Addendum No. 1

Project: South Parallel Taxiway Relocation Project

Airport: Cherokee County Airport

KSA Project No.: 102355

UNDERDRAIN PLAN 1

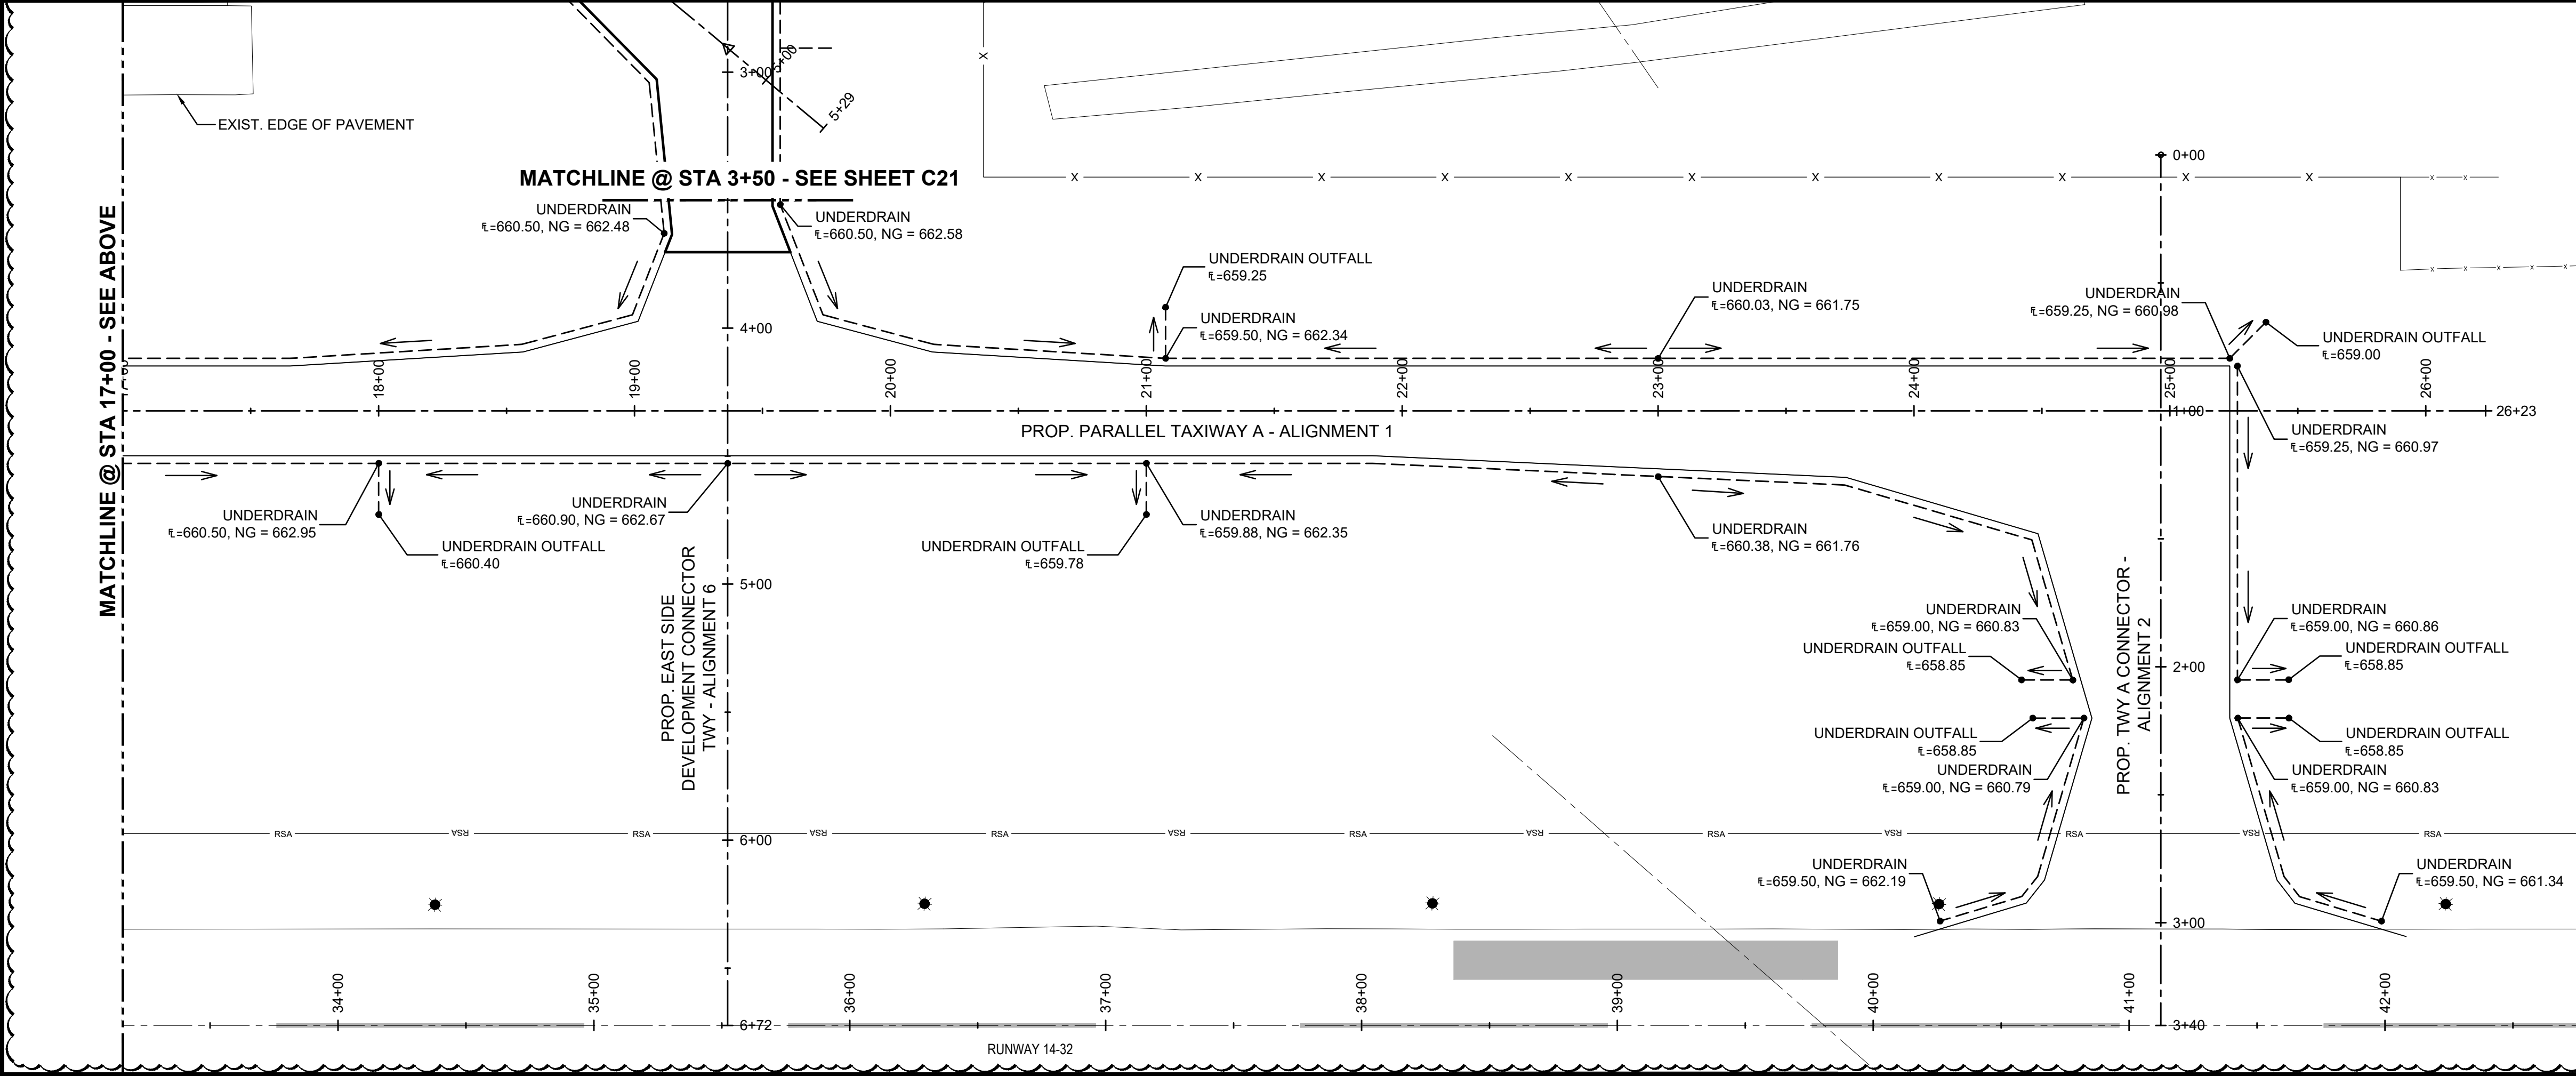
- A. Plan Sheet C05, Stockpile Location and Haul Route Plan
 - 1. Replace with the attached Revised Plan Sheet C05, Stockpile Location and Haul Route Plan.
- B. Plan Sheet C20, Underdrain Plan 1
 - 1. Replace with the attached Revised Plan Sheet C20, Underdrain Plan 1.
- C. Plan Sheet C21, Underdrain Plan 2
 - 1. Replace with the attached Revised Plan Sheet C21, Underdrain Plan 2.

1. Question: What are the depths of the edge drains in the asphalt bid schedule?

8. Question: Are there elevations associated with the underdrains?

Response: *The depth of the edge drains varies. We have revised Sheet C20 and C21, where there are now proposed NG elevations that coincide with edge drain flowlines.*

Response: *Yes, please refer to sheet C020 and C021.*
